**Seismic Walkdown Checklist (SWC)**

Equipment ID No.: 1VQ034

Equipment Description: DW VENT/PURGE OTLT UPSTRM ISOL

Project: LaSalle 1 SWEL

Equipment ID No.: 1VQ035

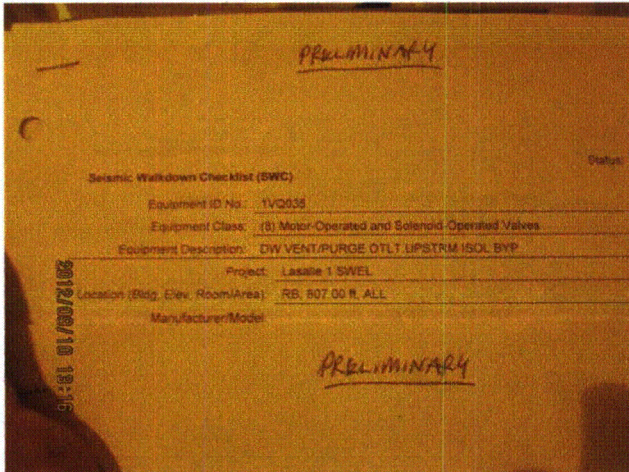
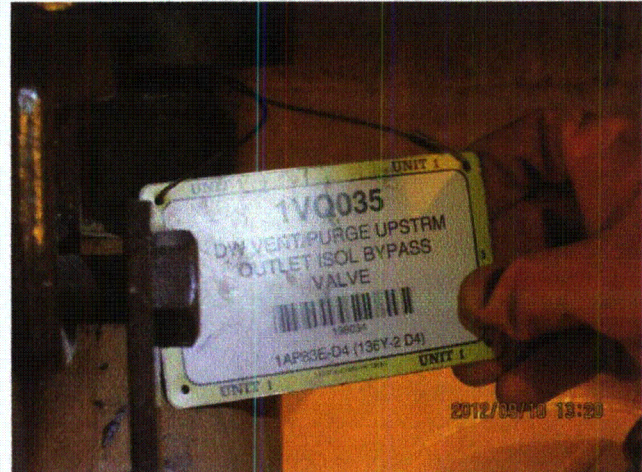
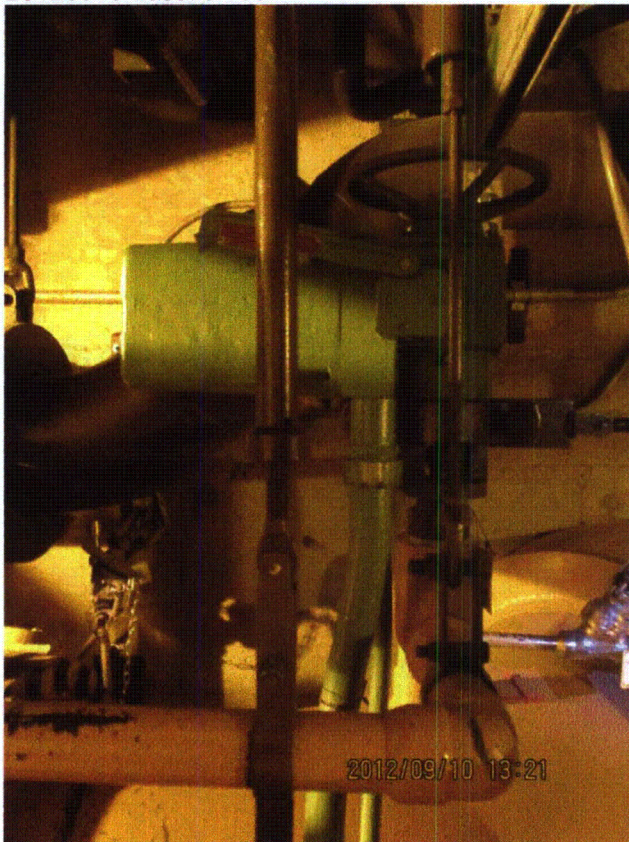
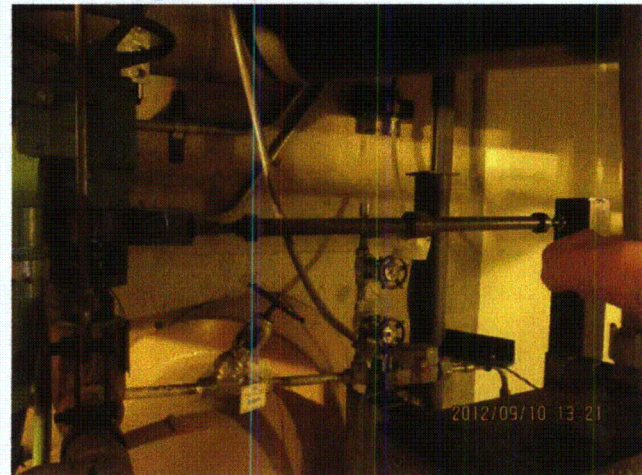
11. Have you looked for and found no adverse seismic conditions that could adversely affect the safety functions of the equipment? Yes  
*Approximate 1" clearance between flexible conduit connection to valve operator and floor judged to be acceptable.*

Equipment ID No.: 1VX04C

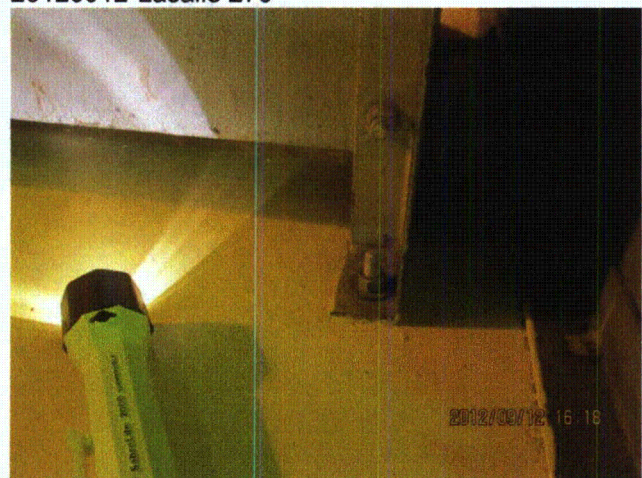
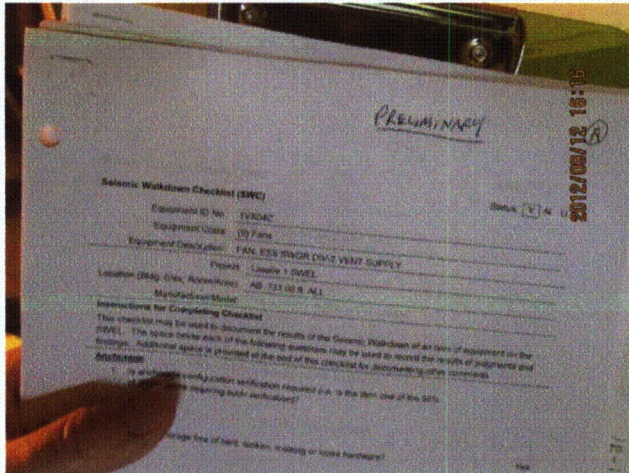
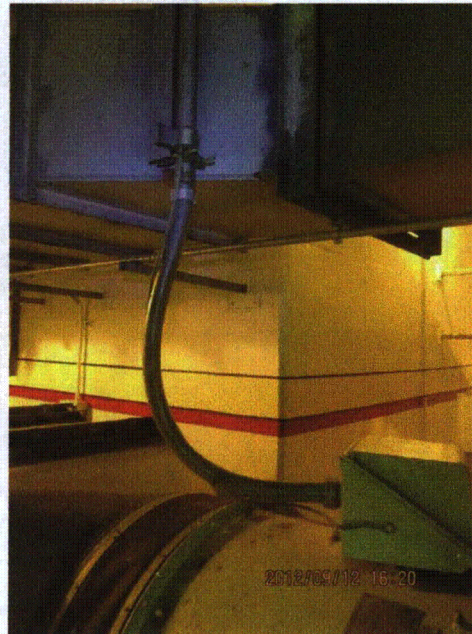
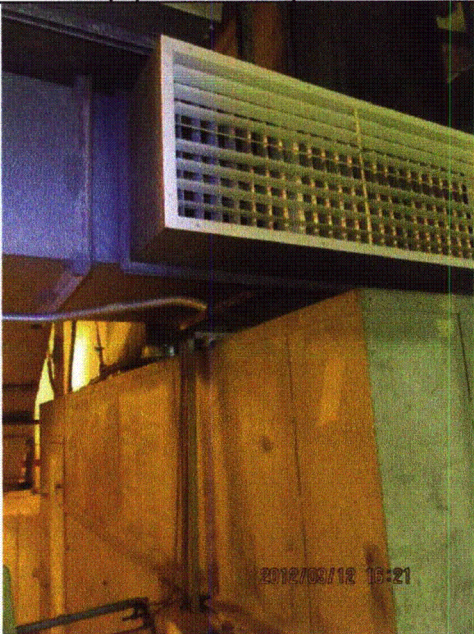
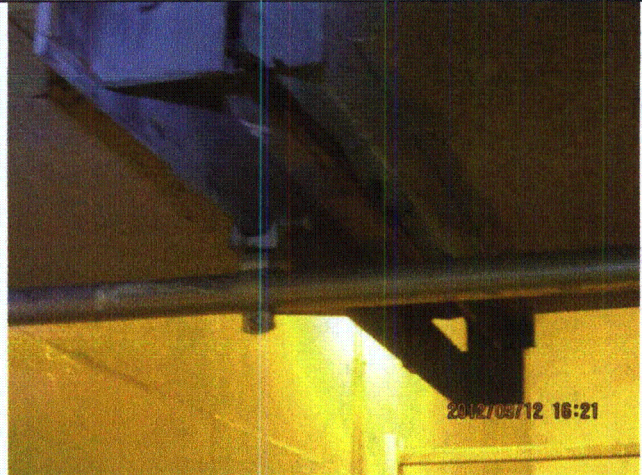
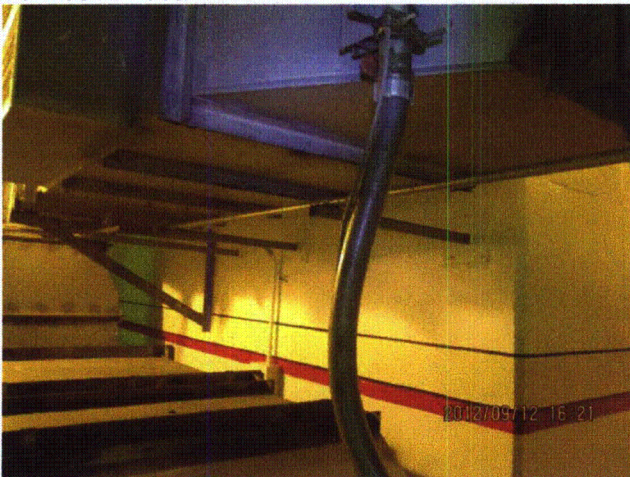
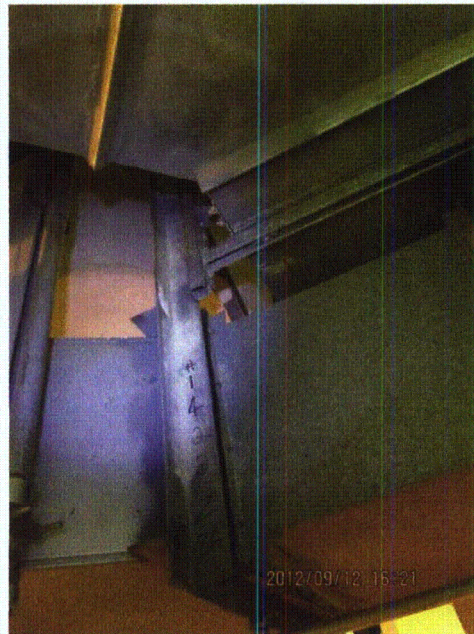
5. Is the anchorage configuration consistent with plant documentation? (Note: This question only applies if the item is one of the 50% for which an anchorage configuration verification is required.) Yes  
*Anchorage shown on drawings M-1566, Rev. E and M-1592, Sheet 19, Rev. E.*

Equipment ID No.: 1VX05C

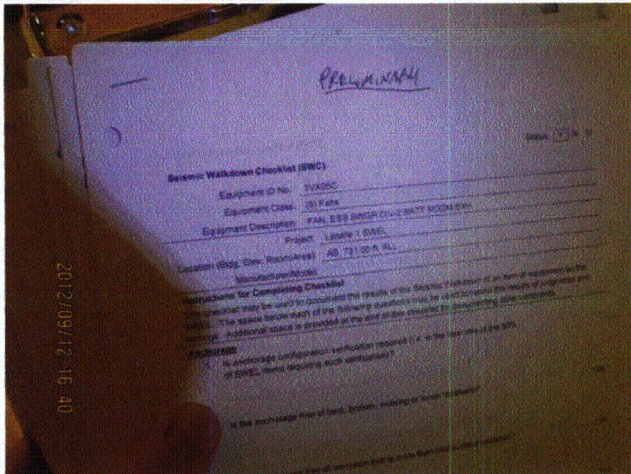
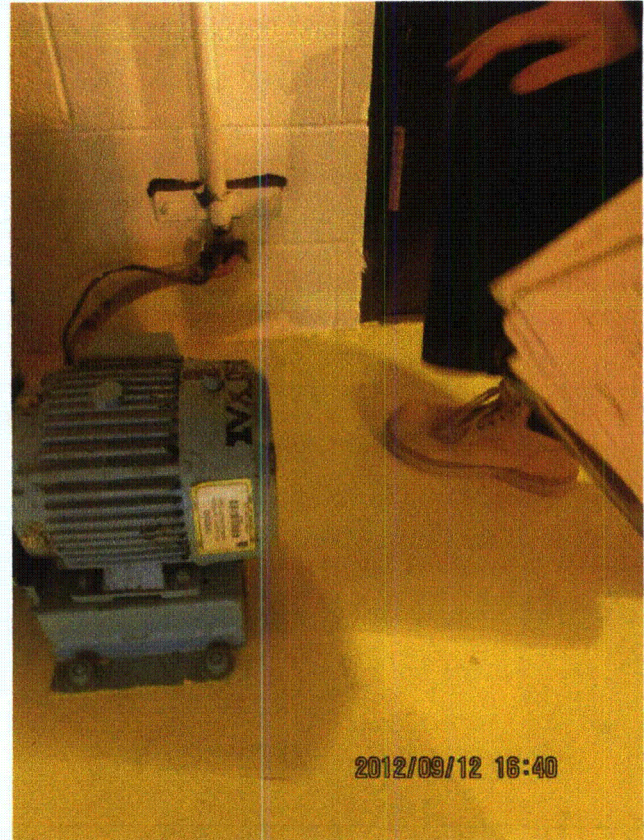
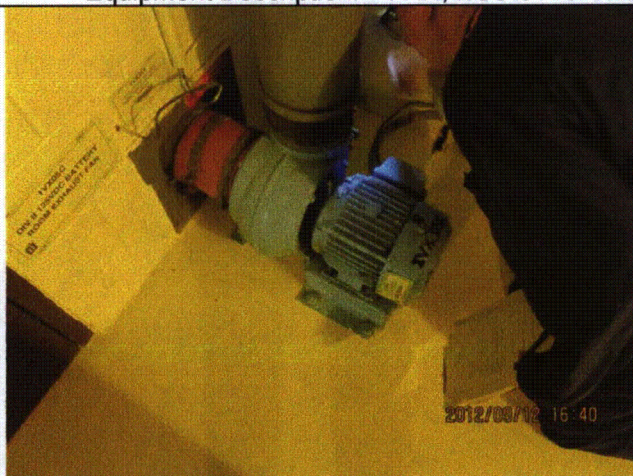
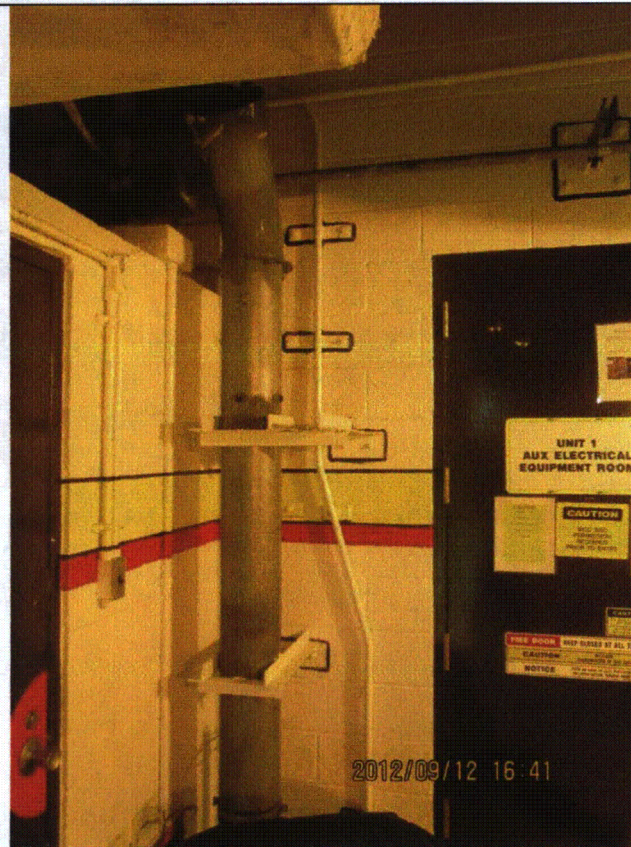
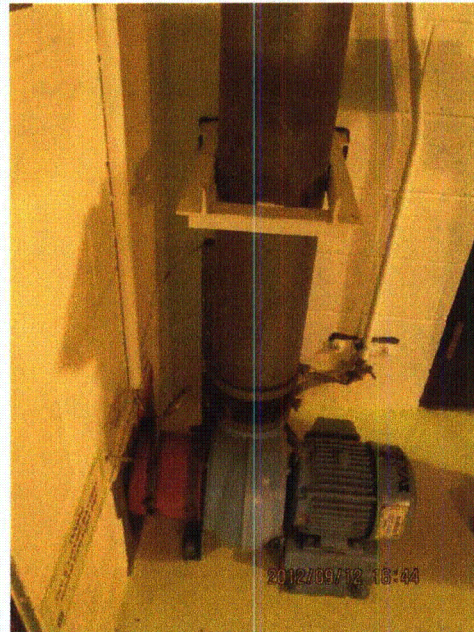
7. Are soft targets free from impact by nearby equipment or structures? Yes
8. Are overhead equipment, distribution systems, ceiling tiles and lighting, and masonry block walls not likely to collapse onto the equipment? Yes  
*Overhead light fixtures judged to be acceptable.*  
*Adjacent masonry walls are safety-related per drawing A-186, Rev. AR.*
9. Do attached lines have adequate flexibility to avoid damage? Yes
10. Based on the above seismic interaction evaluations, is equipment free of potentially adverse seismic interaction effects? Yes

Equipment ID No.: 1VY03C

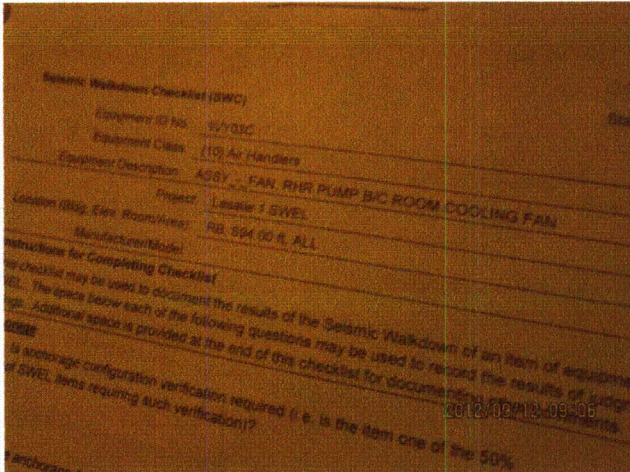
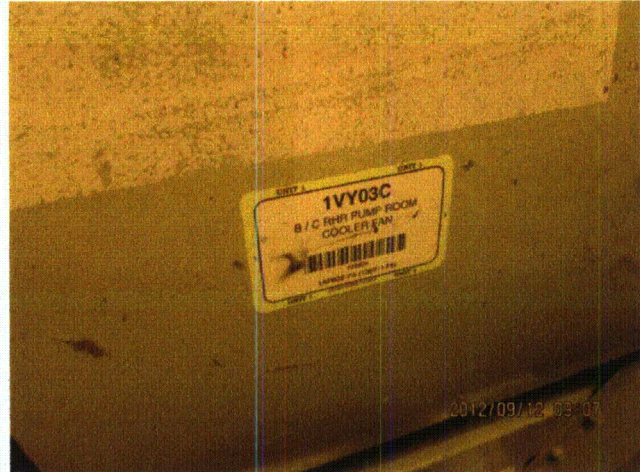
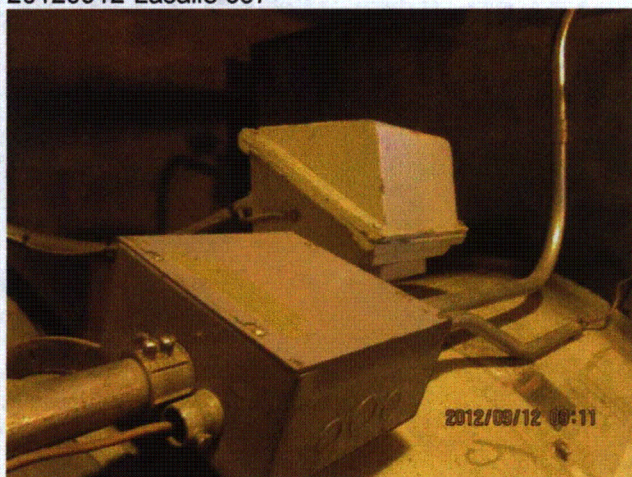
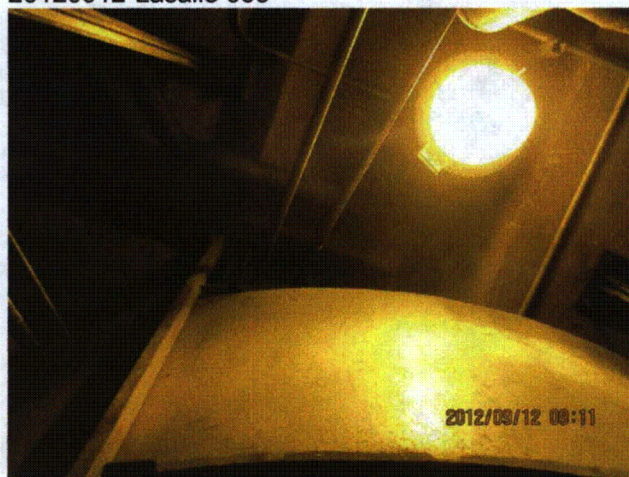
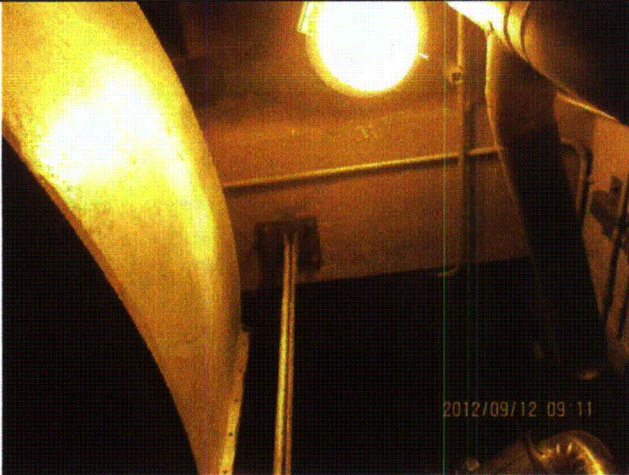
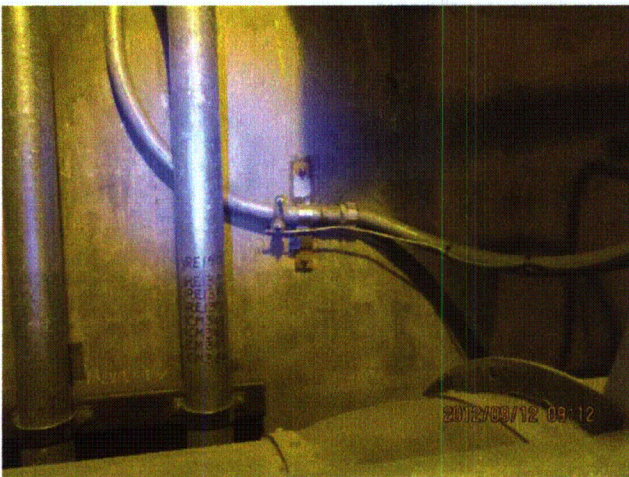
1. Is anchorage configuration verification required (i.e., is the item one of the 50% of SWEL items requiring such verification)? Yes
2. Is the anchorage free of bent, broken, missing or loose hardware? Yes  
*Minor lack of thread engagement on one anchor judged to be acceptable.*

3. Is the anchorage free of corrosion that is more than mild surface oxidation? Yes
4. Is the anchorage free of visible cracks in the concrete near the anchors? Yes  
*Minor shrinkage cracking in grout pad judged to be acceptable.*

5. Is the anchorage configuration consistent with plant documentation? (Note: This question only applies if the item is one of the 50% for which an anchorage configuration verification is required.) Yes  
*Anchorage shown on drawings M-1570, Rev. B and M-1590, Sheet 8, Rev. L.*

8. Are overhead equipment, distribution systems, ceiling tiles and lighting, and masonry block walls not likely to collapse onto the equipment? Yes  
*Overhead light fixtures judged to be acceptable.*

Equipment ID No.: 1VY05C

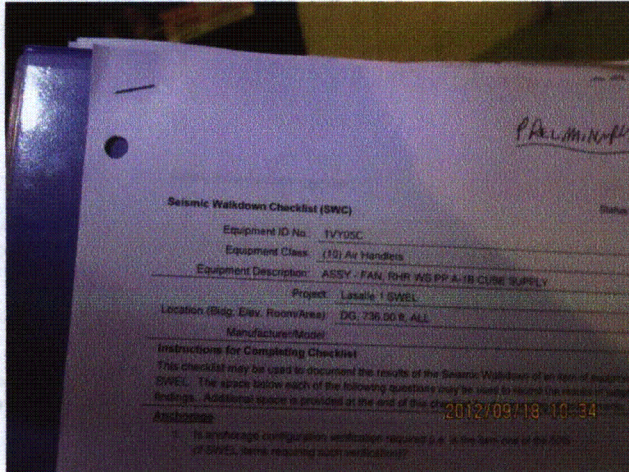
7. Are soft targets free from impact by nearby equipment or structures? Yes
8. Are overhead equipment, distribution systems, ceiling tiles and lighting, and masonry block walls not likely to collapse onto the equipment? Yes  
*Masonry walls in room are safety-related per drawing A-277, Rev. U.*  
*Overhead light fixtures judged to be acceptable.*
9. Do attached lines have adequate flexibility to avoid damage? Yes
10. Based on the above seismic interaction evaluations, is equipment free of potentially adverse seismic interaction effects? Yes

Equipment ID No.: 1VY06C

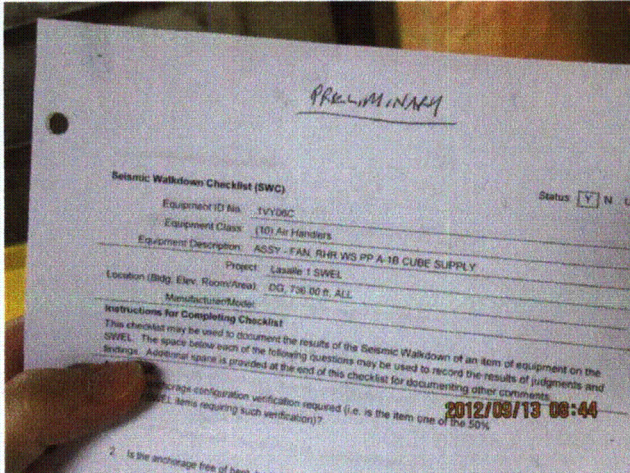
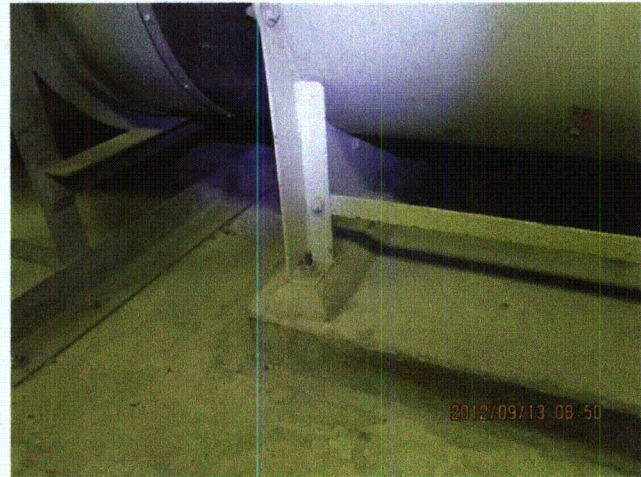
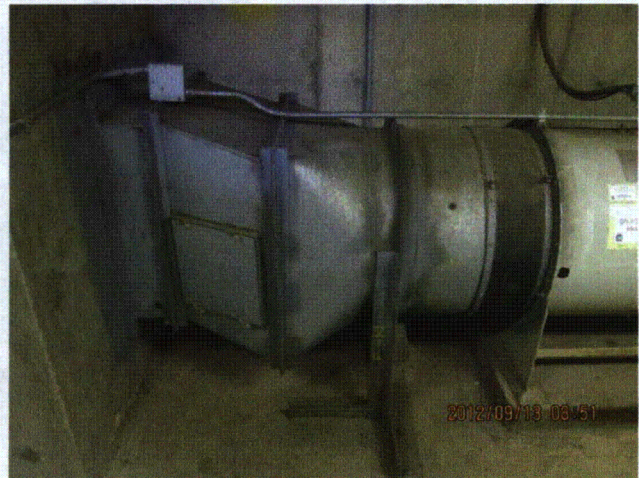
7. Are soft targets free from impact by nearby equipment or structures? Yes
8. Are overhead equipment, distribution systems, ceiling tiles and lighting, and masonry block walls not likely to collapse onto the equipment? Yes  
*Overhead light fixtures with open S-hooks. Movement during seismic event attenuated by nearby conduit supports and trays. Seismic interaction judged to not be credible. See IR 1406922.*
9. Do attached lines have adequate flexibility to avoid damage? Yes  
*Adjacent masonry walls are safety-related per drawing A-277, Rev. U.*
10. Based on the above seismic interaction evaluations, is equipment free of potentially adverse seismic interaction effects? Yes
